WACS 59293

Please find attached an original and four (4) copies of our "Notice Of Intent To Use the General Permit to Construct/Operate a Soil Thermal Treatment Facility" for your review.

Re: Rinker Materials Corporation Thermal Treatment Facility General
Permit No: SO13-195017

GROUNDWATER MONITORING PLAN

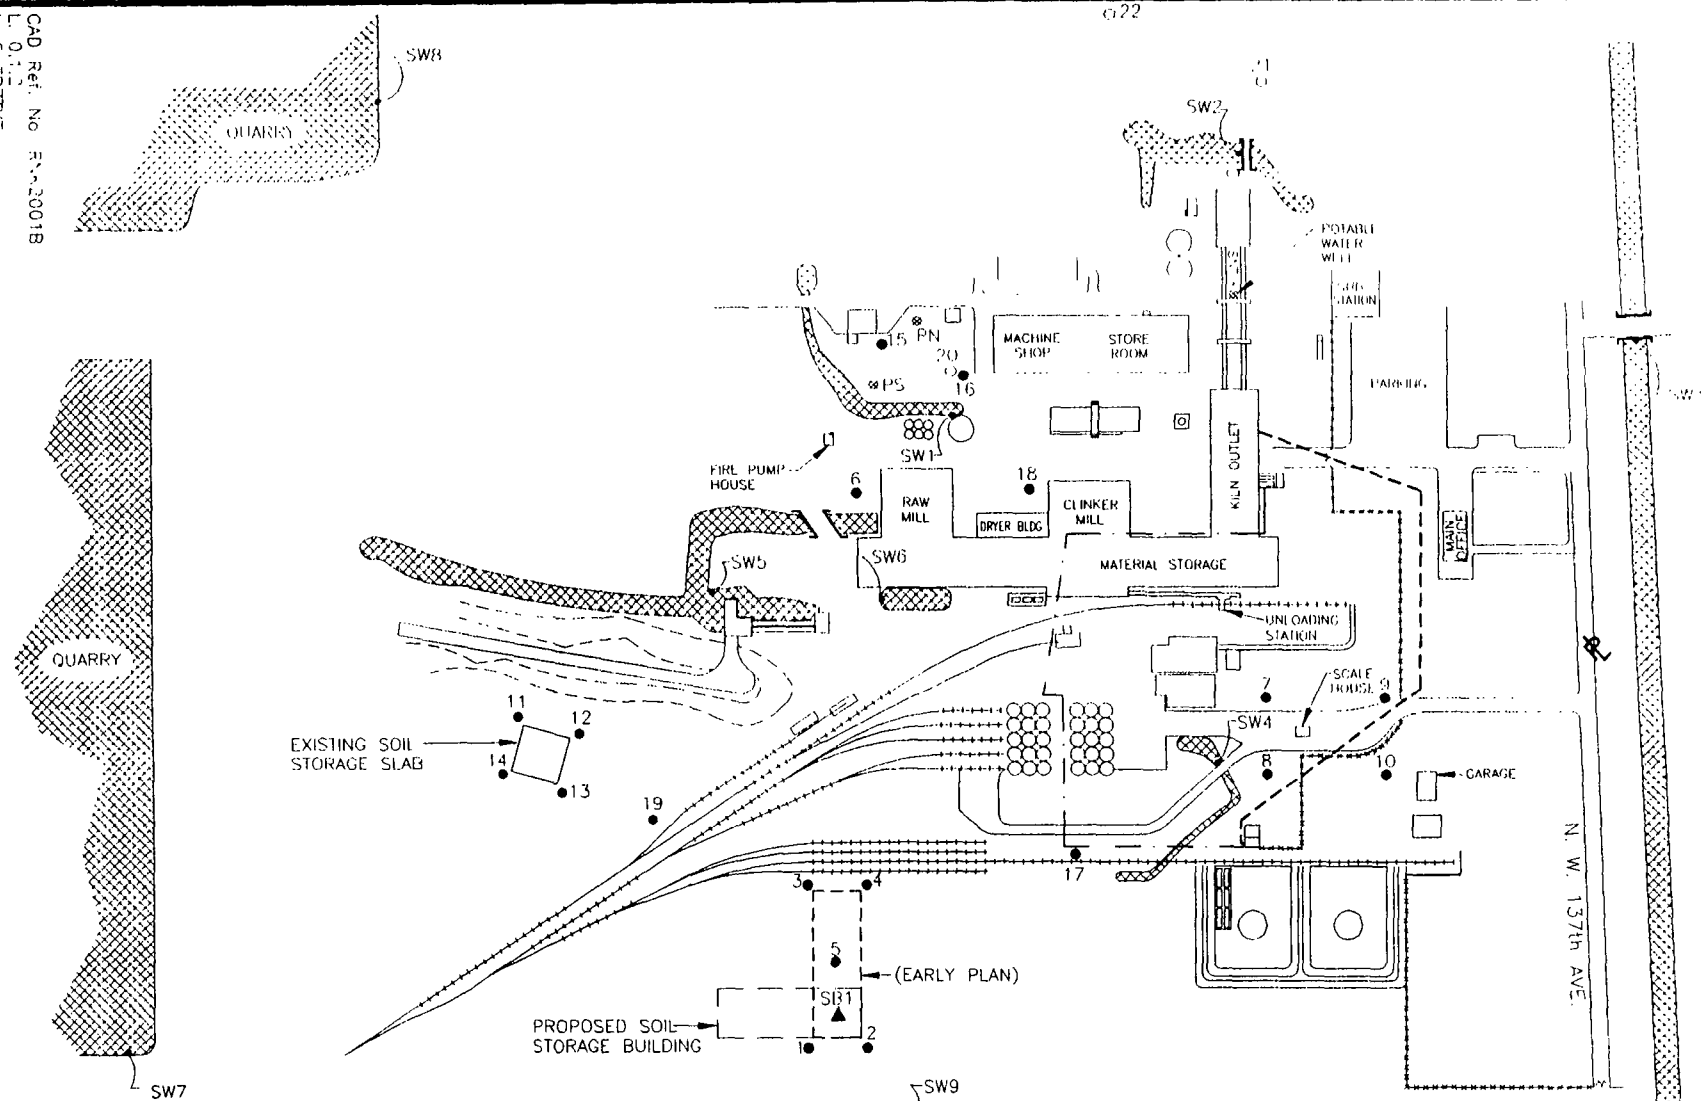
Request 3. On Figure 2, show all surface water features that are shown on Plate 1 (Dames and Moore 12/9/87) and Exhibit 1. How deep are the little lakes and the canal? Do they breach the dense limestone?

Response 3. All significant surface-water features are shown on Exhibit A1. The pits excavated by Dames & Moore have been backfilled with materials excavated from the pits. The "pond-like area" and "lake" on Dames & Moore's Plate 1 correlate with surface-water bodies connected to SW1 and SW5, respectively. Please note that Dames & Moore's Plate 1 is conceptual in nature, not to scale.
